Re: Rio Grande LNG, LLC and Rio Bravo Pipeline Company, LLC  
Docket Nos. CP16-454-000 and CP16-455-000

**FERC October 27, 2016 Engineering Information Request, No. 2 on Rocket Launch Failures Siting Concerns:**

**Response:**

Figure EIR 2-1 Relative Distances between the Spaceport and the Terminal, and the BSC

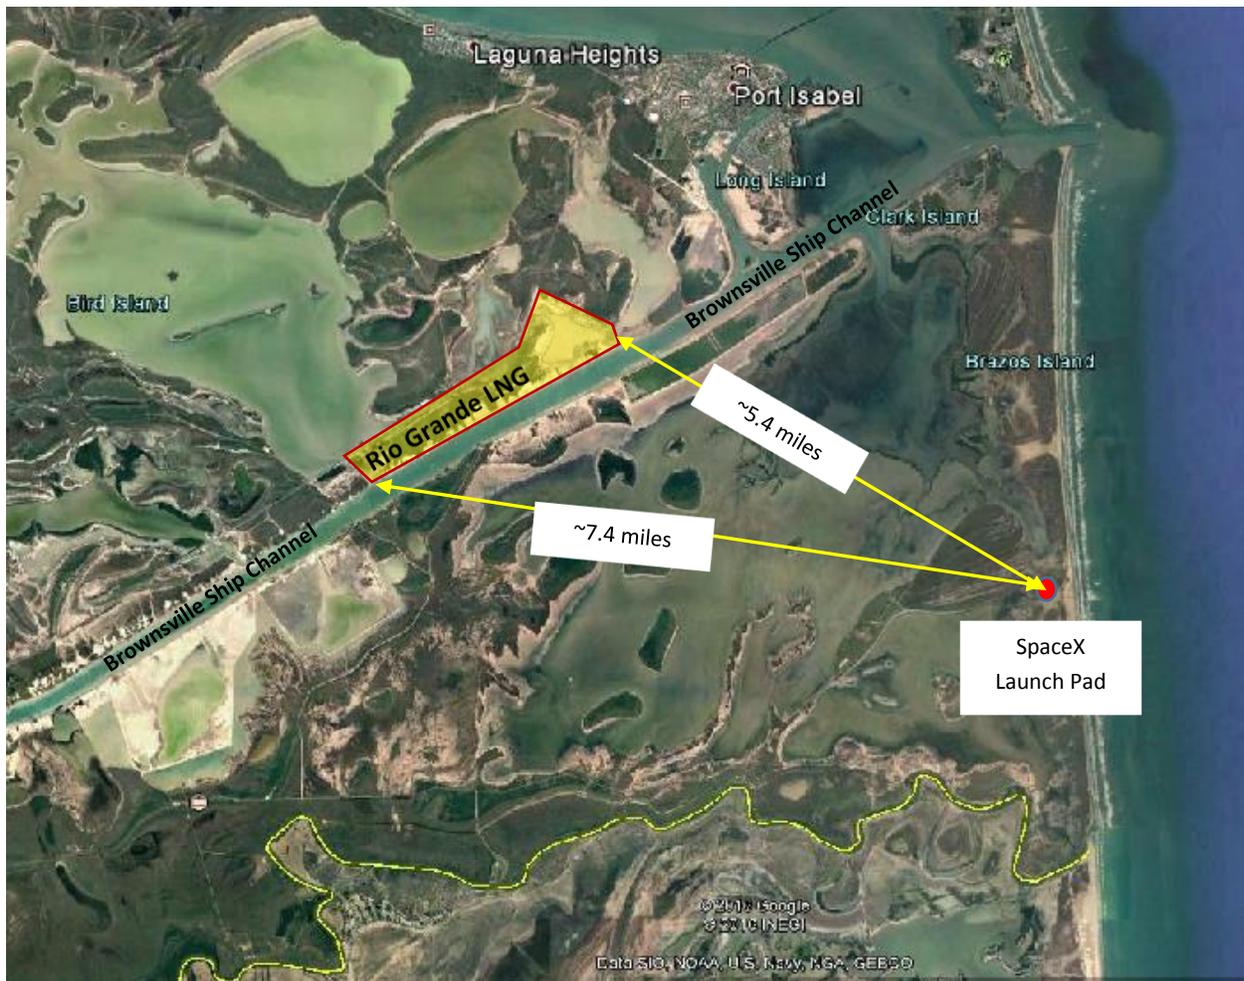
- a. A consequence analysis was performed by ACTA and includes a quantitative modeling analysis to determine if the hazards from the Spaceport could reach or extend into the Terminal boundary or BSC (see Figure EIR 2-1 for relative distances). Hazard zones impacting the Terminal boundary and BSC could potentially impact personnel or impact the Terminal facilities based on the design failure limits of occupied and unoccupied buildings (walls and roofs), tanks (outer walls and roofs), piping, and other equipment. The results of this consequence analysis are contained herein as Attachment B, with specific results summarized below.

As the Falcon Heavy represents the most conservative approach to the requested analysis in terms of propellant volume and the number of predicted debris, the RG Developers are presenting the results of the on-ground analysis on the Falcon Heavy launch vehicle for items i. through iv. Due to the differences in the thrust to weight ratio between the Falcon 9 and the Falcon Heavy causing some of the predicted results for the Falcon 9 to present a higher dispersed projectile fall-out risk to the Terminal and the identified critical areas, the in-flight analysis for both

**Figure 8-2 Predicted Fragment Impact Contours Resulting from an On-Pad Falcon Heavy Vehicle Propellant Explosion.**

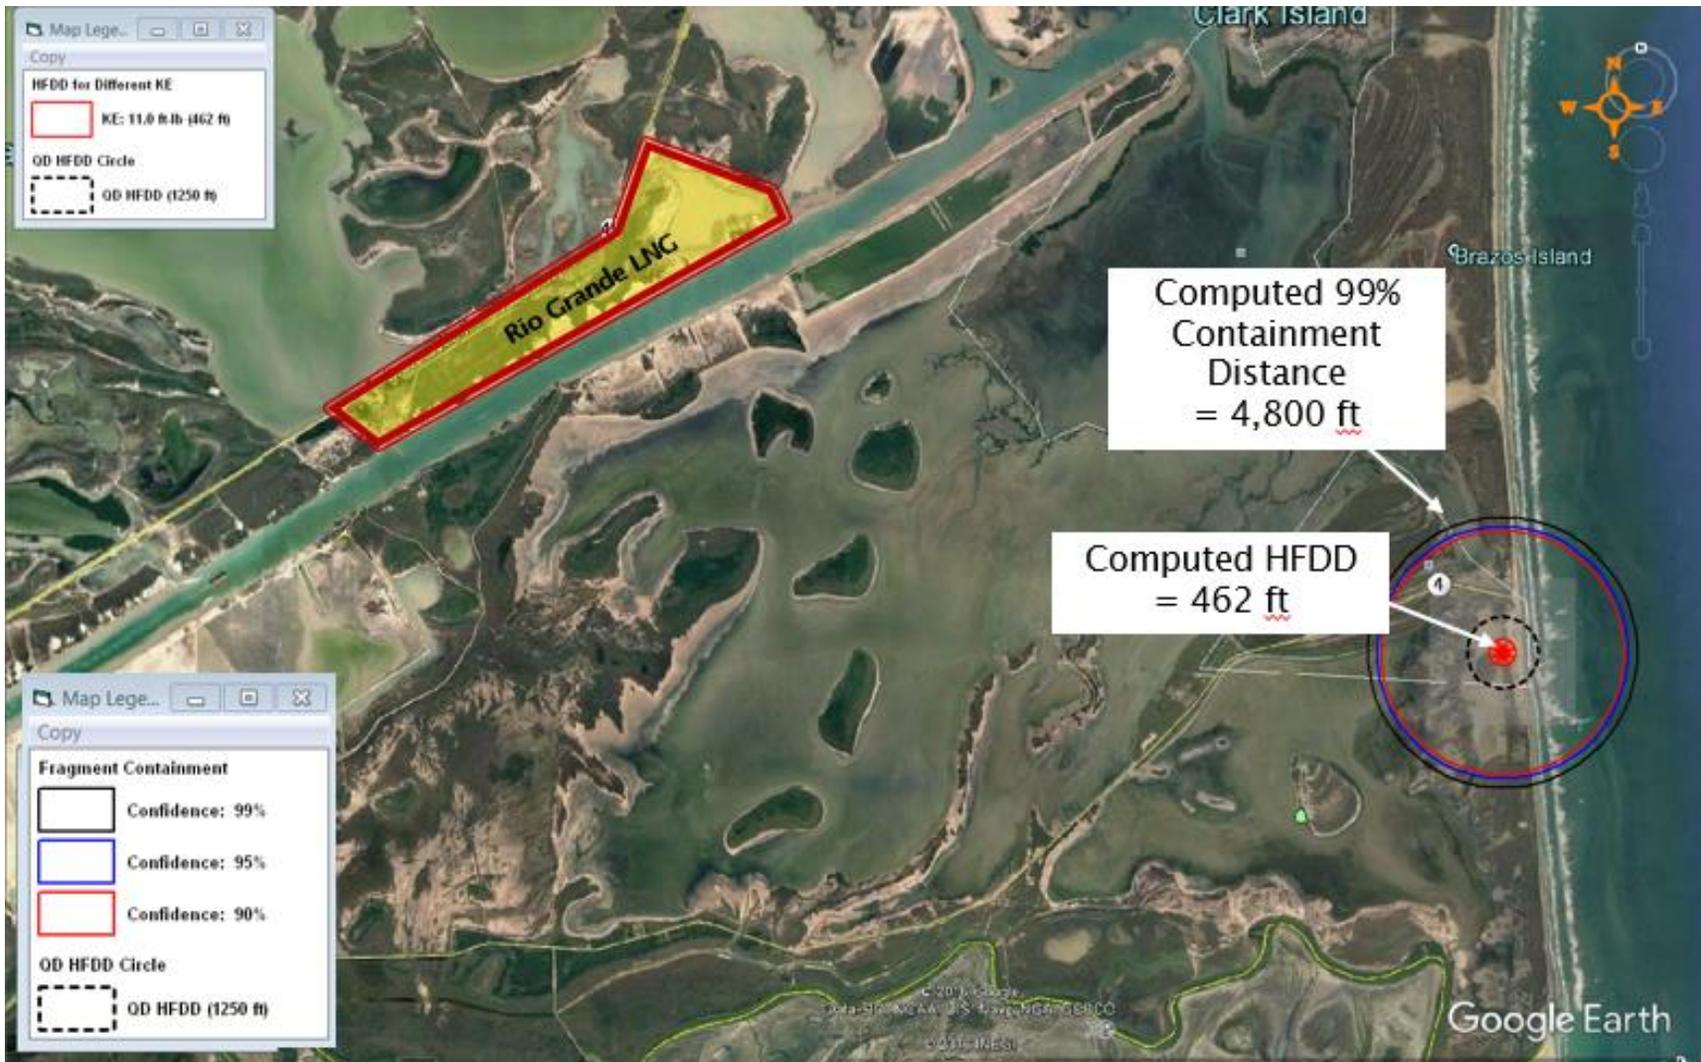
- v. The distances to projectiles from an on-pad vehicle explosion are predicted by ACTA to be contained within an arc of 4,800 feet (with 99% confidence) from the launch pad. No fragments from an on-pad explosion are expected to reach the Terminal boundary or the BSC.

ACTA also applied the Falcon Heavy vehicle fragment debris list (2,505 fragments) and simulated thousands of randomly sampled fragment throw trajectories from the launch pad explosion location. The hazardous fragment density distance (HFDD) was computed to be 462 feet. HFDD is based on a 0.01 probability of a standing person being hit by a fragment with a kinetic energy or 11 foot-pounds (ft-lb) or greater. A more meaningful fragment throw distance is the 99-percentile fragment containment distance, which is computed to be 4,800 feet. The HAZX predicted fragment impact contours are presented in Figure 8-2. Based on the computed overpressure and fragment hazardous threshold contour distances, ACTA concludes that a credible maximum on-pad explosion at the Boca Chica launch pad location will not present any damaging hazards to the Terminal or BSC.

**Figure 9-2 Falcon 9 V1.1 Impact Probability Contours for a 100,000 Square Foot Reference Impact Area with Debris Impact Kinetic Energy Above 10,000 Foot-Pounds Using a Representative Adverse Wind Profile.**

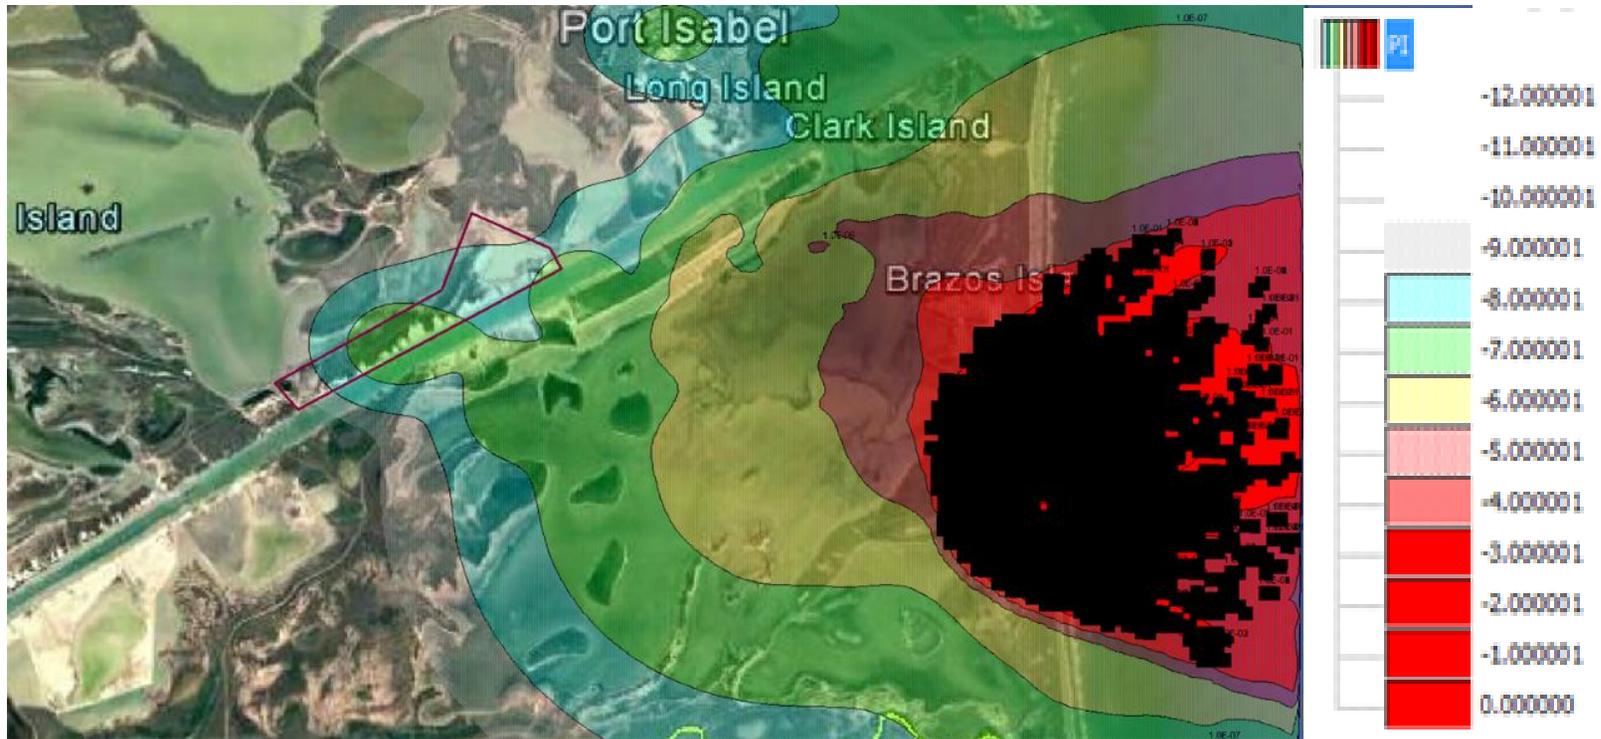
- b. The probability (per launch basis) and frequency (per year basis) of a launch failure, and subsequent debris, that would extend into the Terminal boundary or the BSC were evaluated taking into account both a non-adverse wind condition launch window, which occurs approximately 97.3% of the year, and an adverse wind condition launch window, which occurs approximately 2.7% of the time. The probability of impacting the Terminal critical assets for a launch occurring during the non-adverse wind condition launch windows is at least 1 to 2 orders of magnitude less than that of an adverse wind condition (less than a 1 in 5,000,000 occurrence per launch). This will result in a probability of impacting the Terminal critical assets with less than a 1 in 100,000,000 occurrence per launch. Additionally, the probability of an individual event that would reach or extend into the Terminal boundary, cumulatively impacting the Terminal assets, or the BSC does not exceed the FAA criteria of  $1 \times 10^{-6}$  per launch (14 CFR 417).

Figure 9-2 illustrates a representative set of impact probability contours for the Falcon 9 V1.1 vehicle for a selected set of impact reference area and minimum impact kinetic energy, and Figure 9-3 illustrates a representative set of impact probability contours for the Falcon Heavy vehicle for the same selected set of impact reference area and minimum impact kinetic energy.
